**Change Notification #:** 112549 - 01

**Change Title:** Intel® Desktop Board DH61AG, Boxed & Bulk  
PCN 112549-01, Product Material  
Change USB 3.0 Stepping

**Date of Publication:** September 19, 2013

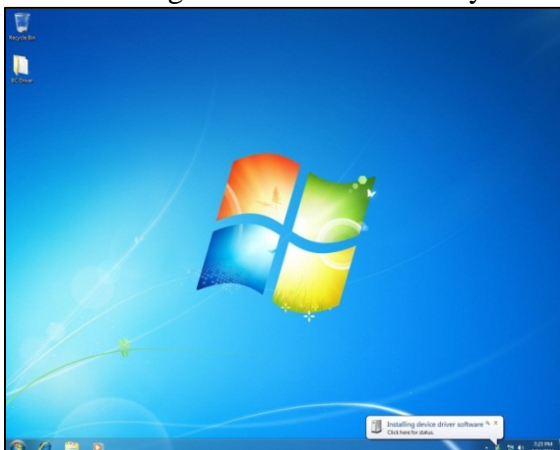
Intel will be changing the USB 3.0 controller on the Intel® Desktop Board DH61AG from F1 stepping back to A stepping to increase the manufacturability.

The original OS image to first boot up system with A stepping USB 3.0 IC will pop up driver reload message. Install automatically as in the image below.

It has also been observed that the change for the USB3.0 controller reports a "New device detected" in some operating systems. Microsoft\* Windows will display a message and automatically install the necessary drivers; however, customers may wish to update their OS image to avoid the message.
